**PLANNING AND ZONING COMMISSION
STAFF REPORT**

Planning Variance case no. PV15-12: Jeremy Richardson

CASE DESCRIPTION: a request for approval of two separate variances to allow a 143-foot reduction from the minimum 275-foot drive separation distance and a 14-foot reduction to the 50-foot driveway throat depth generally required on properties along major arterial streets, to allow a new driveway with a driveway throat depth of 36 feet to be located within 132 feet of East 29th Street

LOCATION: 2305 East Villa Maria Road, at the southeast corner of the intersection of East Villa Maria Road and East 29th Street, being Lot 1 in Block 1 of the Villa Maria Gulf Service Subdivision in Bryan, Brazos County, Texas

EXISTING CONDITIONS

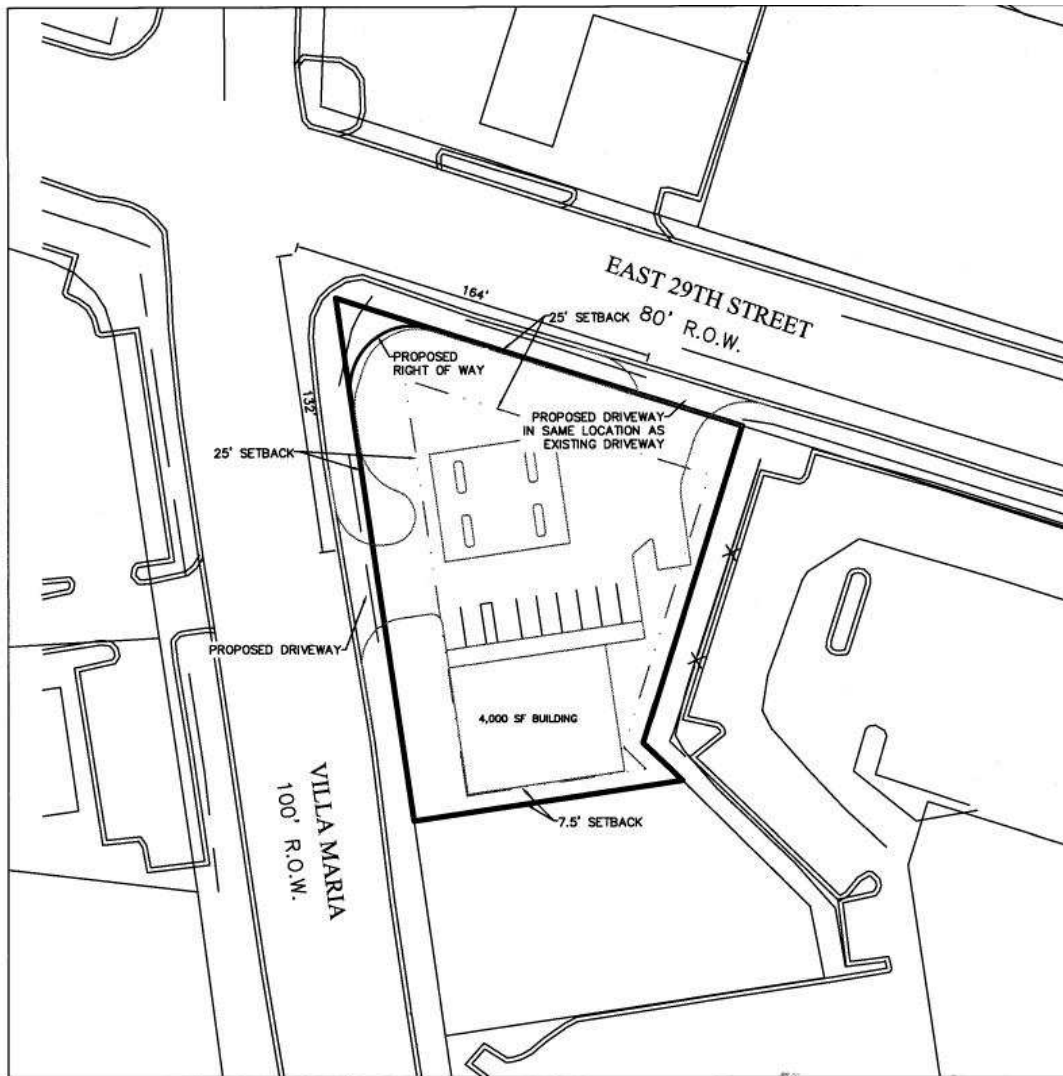
The subject property was developed sometime in the early 1980's prior to the City of Bryan adopting driveway separation standards. There are currently 4 driveways taking access to the site, 2 along E. Villa Maria Road and 2 along East 29th street. In their current configuration, the existing driveways on the property neither meet adopted separation requirements nor established throat depth lengths. Since all driveways were constructed prior to the adoption of applicable standards, they are considered legal non-conforming driveways and are allowed to remain in place until the site is redeveloped

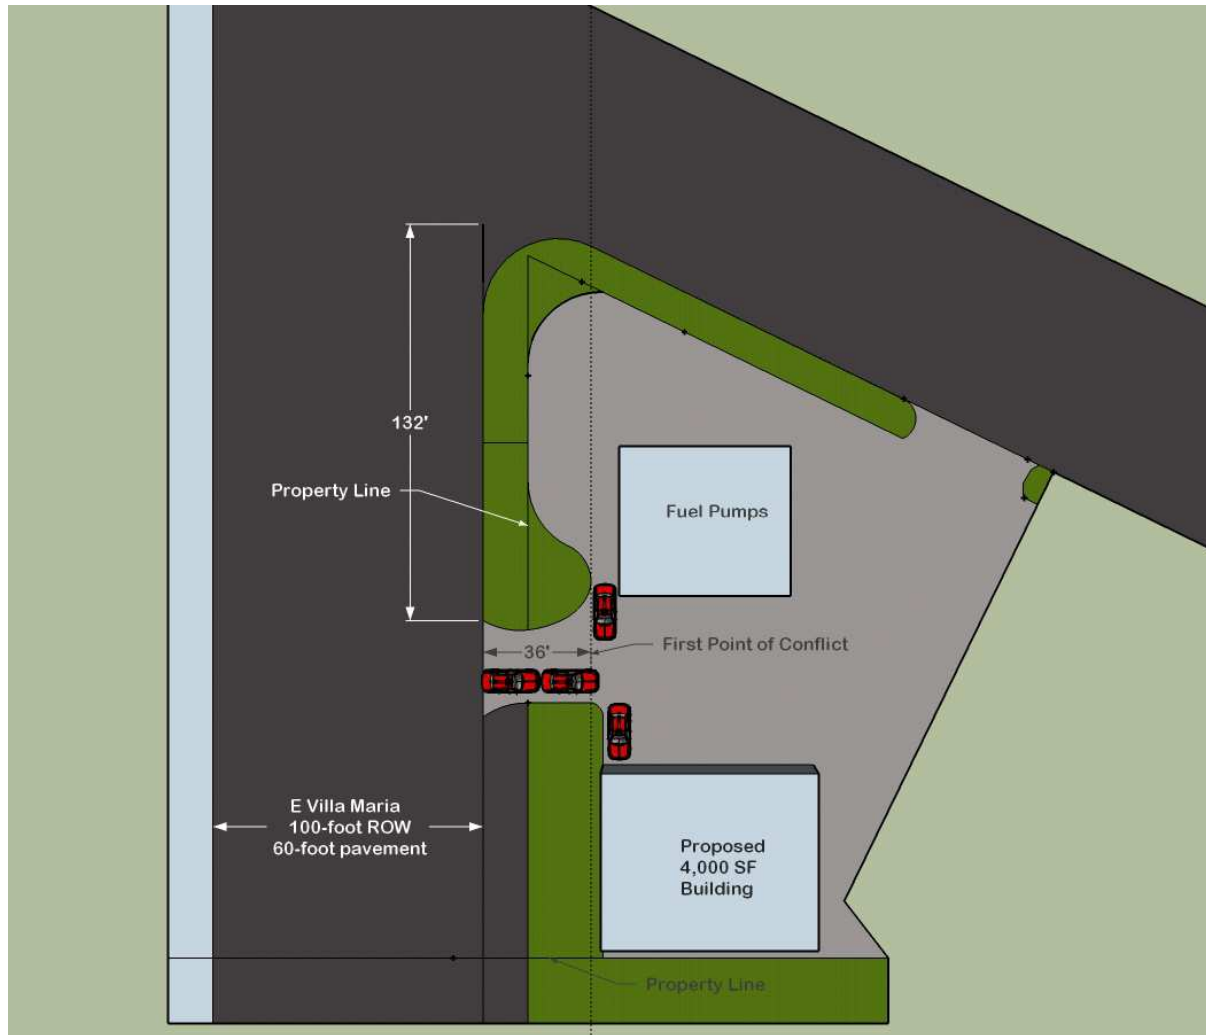
The Land and Site Development Ordinance defines throat depth as a “distance measured from the edge of pavement of the street to the first point of conflict”. A first point of conflict is the point on any driveway where to automobiles could possible interact with each other. The distance of a required throat depth is determined by the functional classification of the adjacent roadway. In this case any driveway accessing East Villa Maria Road is required to have a minimum 50-foot throat depth.

The intend of throat depth requirements is to provide space for motorists to stop and wait for conflicting traffic already in the parking lot to clear so he/she can proceed. At the same time it also minimizes the possibility of vehicles extending out into the adjacent roadway, which reduces crash risk. When the throat length is too short to store queued vehicles, the back of the queue can extend into the roadway and impede the flow of pedestrian and vehicular traffic. Also, a short throat can create conditions that increase opportunities for collisions between vehicles or between vehicles and pedestrians. So, throat length design can affect both the operation of traffic and the safety of the users.

Adequate throat depth varies based on the speed and volume of traffic on the adjacent roadway: the higher the speeds and volumes, the greater throat depth is needed to reduce the risk of rear-end crashes occurring.

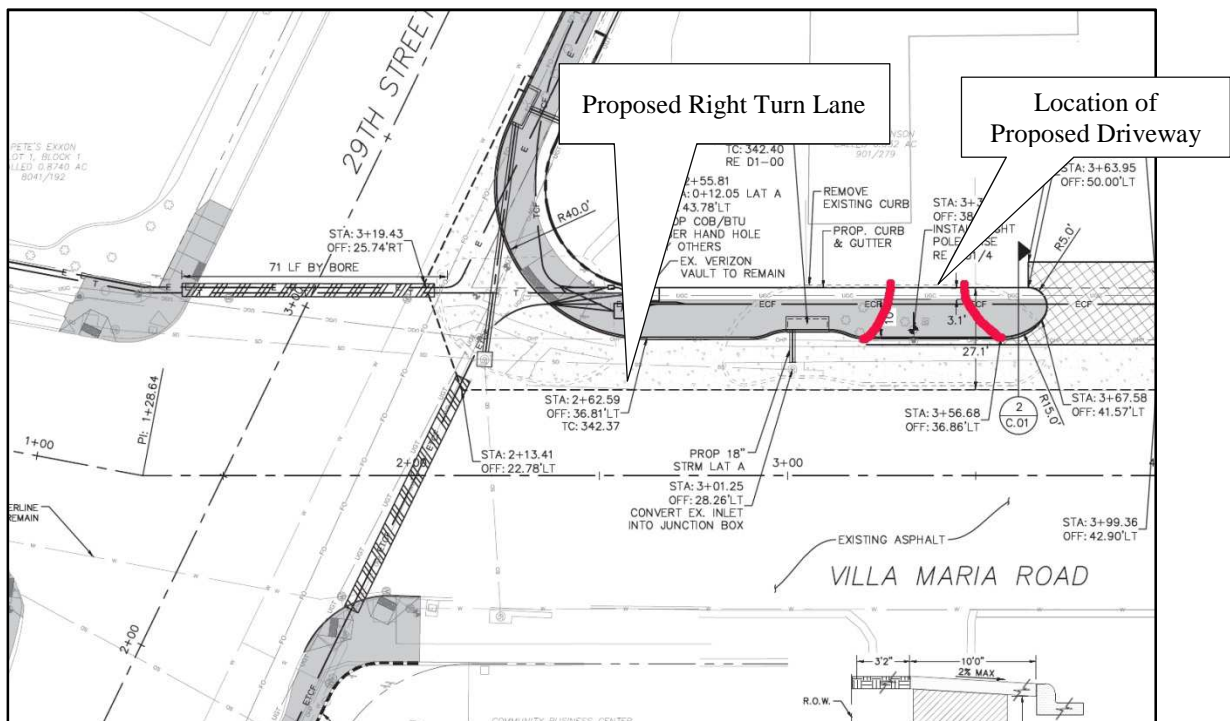
Due to the lot configuration it would not be possible to meet the 275-foot driveway separation requirement were this site undeveloped and the existing driveways did not exist, therefore, staff is recommending approval of the request to allow for the proposed driveway on E. Villa Maria to be located 132 feet from the intersection. According to the City's Engineering Services Department, the proposed driveway location is not any less safe for traffic movements than the existing driveways accessing E. Villa Maria Road.

However, staff contends that a special circumstance or condition affecting does not exist on the subject property such that the strict application of the ordinance deprives the applicant of the reasonable use of the property with regards to a reduction in the minimum 50-foot throat depth requirement. While it is true that the site's unusual shape and location may make adherence to adopted development standards challenging, a final site layout that may support the need for a reduction in driveway throat length has not yet been submitted. As mentioned above, throat length design can affect both the operation of traffic and the safety of the users.

Based on all of the aforementioned considerations, staff recommends **approving** the requested variance for the location of the driveway, but **denying** the requested throat depth reduction.
